GO2-21-084

Subject: **COLUMBIA GENERATING STATION, DOCKET NO. 50-397
RESPONSE TO REQUEST FOR ADDITIONAL INFORMATION RELATED
TO ON-SITE COOLING SYSTEM SEDIMENT DISPOSAL**

RESPONSE TO REQUEST FOR ADDITIONAL INFORMATION

GO2-21-084 Enclosure, Attachment 1:
RP Calculation 21-01 Rev 001

**As-Built Facilities and Commercial Engineering
Drawing of November 2020 Sediment Disposal Cell**

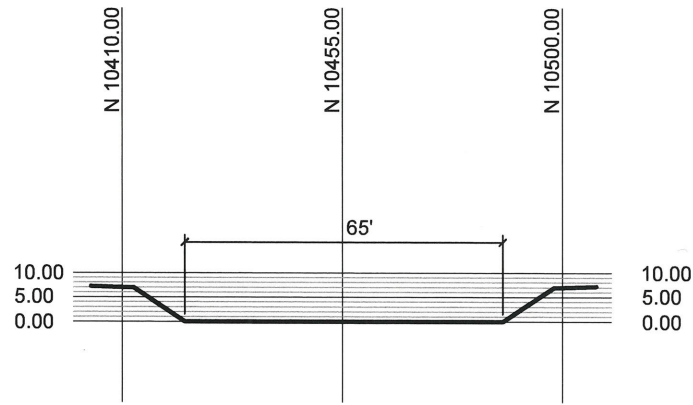
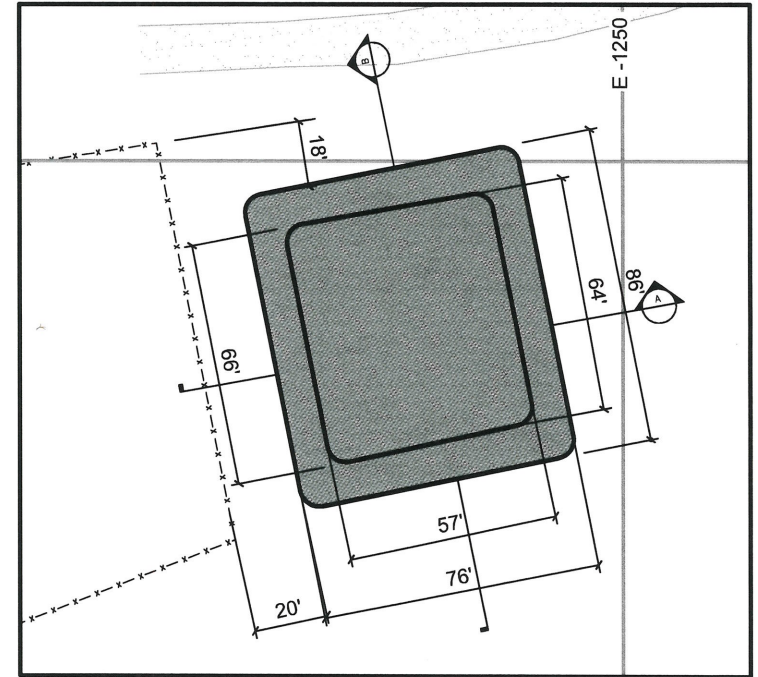
Clarify the total area of the sediment disposal area and the volumes of sediment that have previously been disposed of and have yet to be disposed in the sediment disposal area. Is the 3600 ft² (120 ft X 300 ft) fenced area discussed in the State Environmental Policy Act (SEPA) Environmental Checklist included with Enclosure Attachment 3, the sediment disposal area being considered in this alternate disposal request? If not, provide the area of the sediment disposal area and a reference to these dimensions.

Also, based on the information provided in Sections 1.2 and 5.5.2, clarify if the 2850 cubic yards of material includes the 1400 cubic yards of material that has yet to be disposed and if the total volume of material in the sediment disposal area at the time of closure is 2850 cubic yards or 4250 cubic yards (2850 cubic yards + 1400 cubic yards).

The total area of the sediment disposal area is approximately 48,000 ft². This includes the 36,000 ft² (120 ft X 300 ft) currently used sediment disposal area described in the State Environmental Policy Act (SEPA) Environmental Checklist included with Enclosure Attachment 3 and the 12,064 ft² (116 ft X 104 ft) for the new sediment disposal cell added in November 2020. See Attachment 2 for an As-Built Facilities and Commercial Engineering drawing of the November 2020 sediment disposal cell. As stated in Section 5.5.2, the assumed total volume of sediment to be disposed was 2,850 cubic yards (yd³) over 30 years based on the original 36,000 ft² area. This was calculated in 1995 based on an estimated yearly volume of 60 yd³ per year for the cooling towers and 35 yd³ per year for the spray pond sediments. An analysis of the last ten years provides a more accurate yearly volume of 198 yd³ as mentioned in Section 1.2. We now anticipate approximately 200 yd³ per year for the remaining life of the plant. This sediment will be placed in the current disposal area which should have space for another 200 yd³ and the November 2020 sediment disposal cell which should have room for another 1260 yd³ as shown in the Attachment 2 As-Built Facilities and Commercial Engineering drawing. The total estimated volume in the existing sediment cells at the time of closure will be approximately 4,310 yd³ (2,850 yd³ in existing cells + 200 yd³ to be added to active cells + 1,260 yd³ to be added to the November 2020 sediment cell).
